**DA CP 13-001**

**PROPOSED BEACHFRONT REVETMENT WALL  
NO.8 BERRIMA CRESCENT, UMINA BEACH**

**DRAFT ASSESSMENT REPORT & RECOMMENDATION  
PREPARED FOR THE NSW COASTAL PANEL**

Figure 2 - Proposed Revetment Wall Design

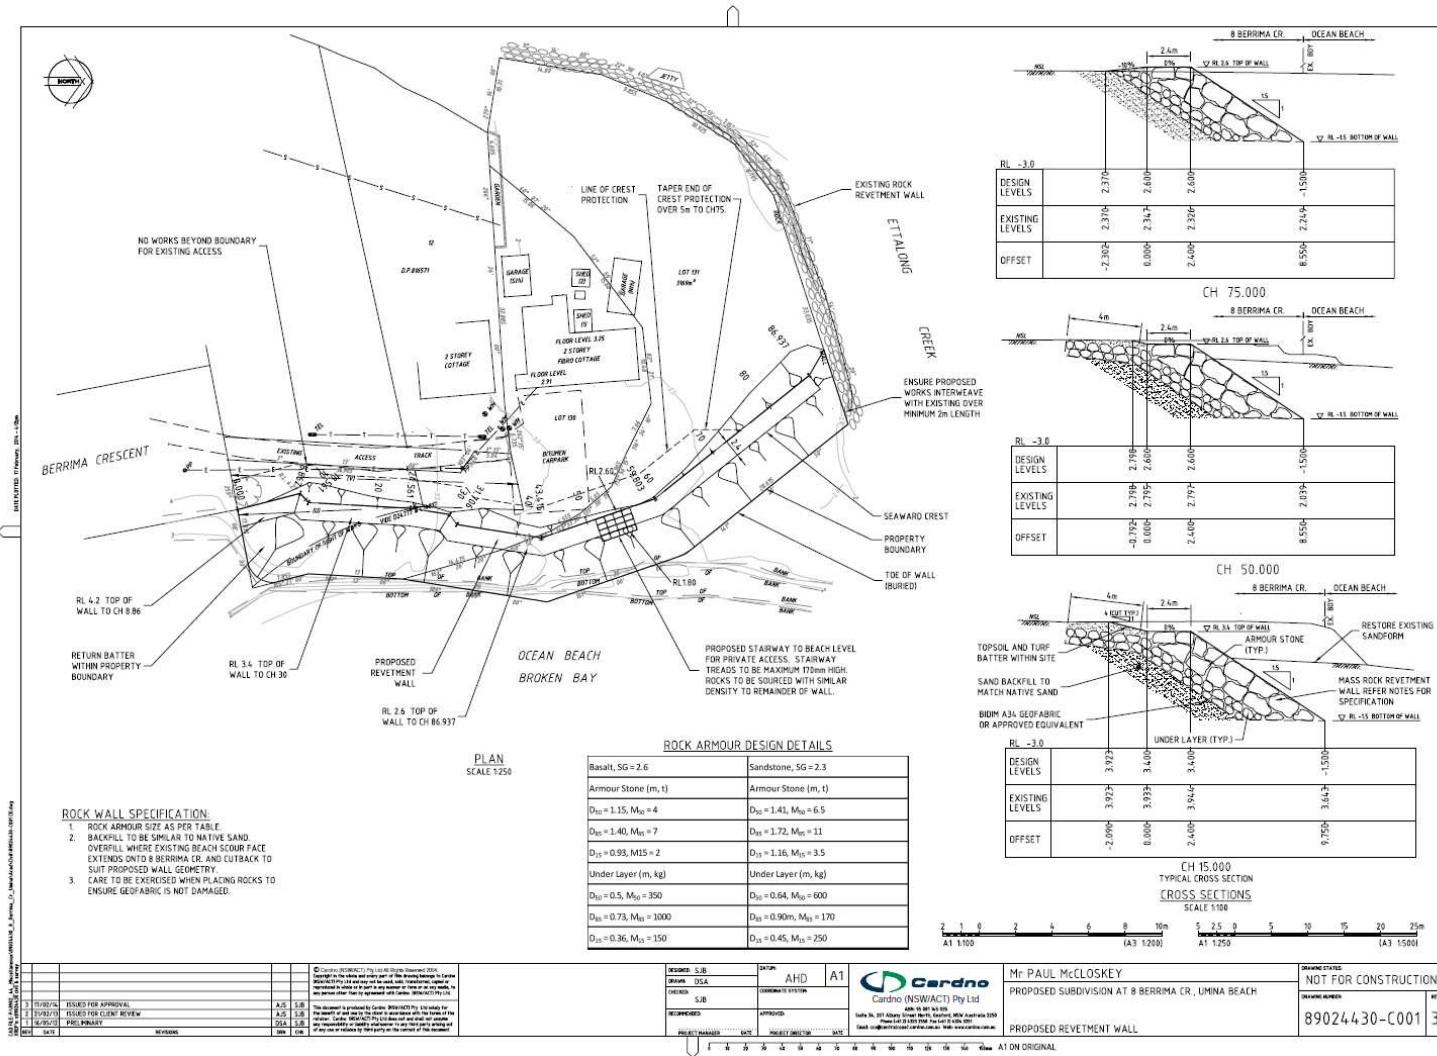
- Clarification on the location of the proposed return of the wall as depicted in drawing No. 89024430-C001. The application states the wall is to be constructed entirely on the applicant's (private) land. However, this figure indicates the southern return of the wall is to be constructed beyond the property boundary, and extending onto public land. If the return is to be constructed on public land, landowner's consent will need to be submitted as part of the development application documentation;

- Clarification is sought on the design slope of the seawall. There is a discrepancy between the information in the Statement of Environmental Effects which shows the slope of the wall is 1V:1.5H compared to the design of the wall as shown in drawing No. 89024430-C001 indicates a relatively steep wall design of 1.5V:1H;

- Further information on the justification for the proposed design in terms of its adequacy across its anticipated design life. Specifically:
  - the wall is considered to be of a relatively low height and therefore potentially susceptible to overwash and possible failure,

- the wall has a relatively shallow toe and therefore is potentially susceptible to undermining,
  - the wall design has only a primary and no planned secondary rock fill layer, and therefore may be potentially susceptible to a compromised structural integrity resulting from wave run-up and overwash processes, and

- Information about the proposed method to address these design issues to maintain structural integrity such as deeper toe and higher crest levels, a double layer wall, wall slope and the ability to 'top up' the wall into the future if required;

- Drawing 89024430-C001: A revised revetment wall proposal (Figure 2)
- Drawing 89024430-C002: A revised erosion and sediment control plan (Figure 4)
- A revised coastal engineering assessment (Appendix D).

The design of the revetment wall has been amended to return the southern end wall batter wholly within the property boundary and to amend the cross section and armour stone detail along with the accompanying revised coastal engineering assessment that addresses the various coastal engineering and revetment wall design matters raised the correspondence.
